PROCEDURE FOR ADAPTING 1200
FRAME FOR NOVA II OPERATION

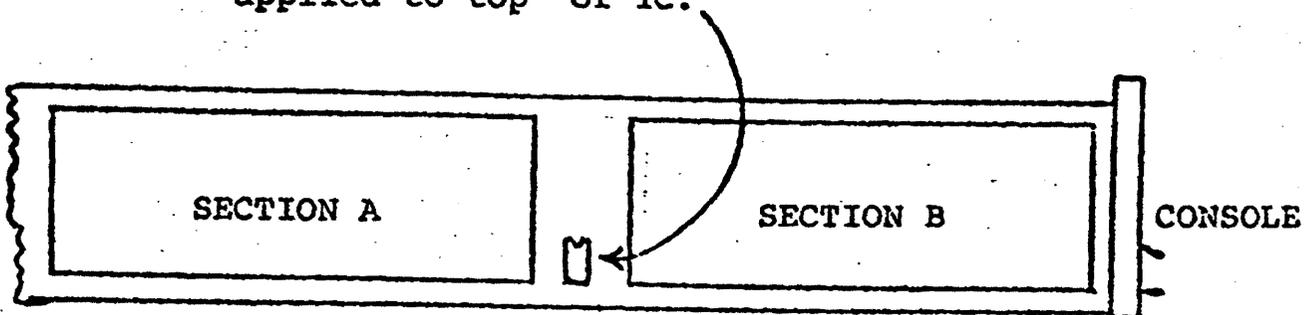
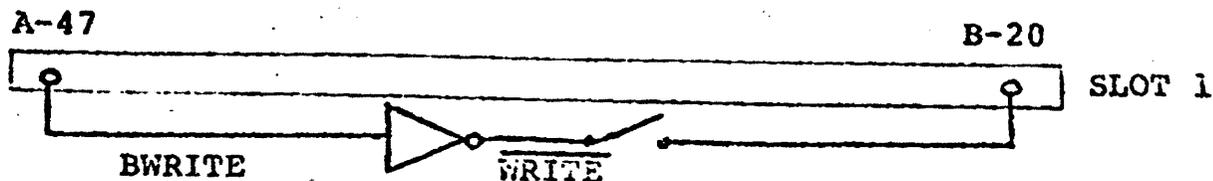
Logic change required:

Invert the Nova II CPU signal BWRITE (A-47) to WRITE (B-20) as required by the Nova II Memory.

1. Attach a 8H90A IC to the area between sections A and B of the backpanel with Alpha adhesive (Part #120-000-003) applied to top of IC.

2. Attach a wire from Pin 7 of IC to ground.
3. Attach a wire from Pin 14 of IC to +5V.
4. Attach a wire from Pin 1 to A-47 of slot 1 on backpanel.
5. Attach one end of a piece of daisy chain to Pin 2 of IC. When Nova II operation is required attach other end of daisy chain to slot 1 B-20. (Note: A switch could be used for convenience).

Switch closed for
Nova II operation.
